RECALL CAMPAIGN

REF. NO. 25 AIR-BAG ELECTRONIC CONTROL UNIT MOUNTING 360 MODENA / 360 MODENA F1

RECALL CAMPAIGN NO. 25

Ferrari 360 Modena Air-Bag Electronic Control Unit Mounting

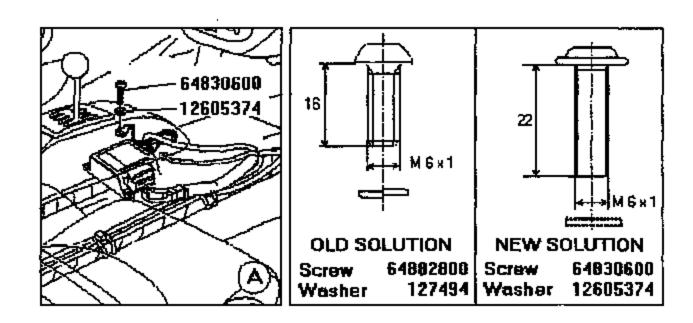
The mounting of the Air Bag Electronic Control Unit (ECU) may not be suited for long term reliability. If left unchanged, the air bag ECU mounting could become weak. If such a condition should occur, the ability of the air bag ECU to sense a crash could be compromised, and if a crash should occur, the air bag

The remedy consists of installing longer screws which ensure

better tightening and securing to the body element.

- Disconnect the battery by means of the switch located in the luggage compartment
- To remove and install the center console cover, follow the procedure outlined in the workshop
 manual "Disassembly of the Central Console" (Volume "2", Section "M", Chapter "M3.02")
- Replace the screws (old part number 64882800) and the washers (old part number 127494) of the air bag electronic control unit (ECU) with the new solution shown in the drawing below (Screw - new part number 64830600, Washer - new part number 12605374).
- Using a proper torque wrench, tighten the three- (3) air bag ECU mounting screws to a torque of 7.5 Nm (5.5 ft.lbs.)
- 5. Reconnect the battery
- 6. Perform the COMPLETE air bag system cycle check with the System Diagnosis 2 (SD2)
- 7. The SD2 air bag system check printout must be faxed to the Ferrari North America Warranty Department at 201 816 0359.
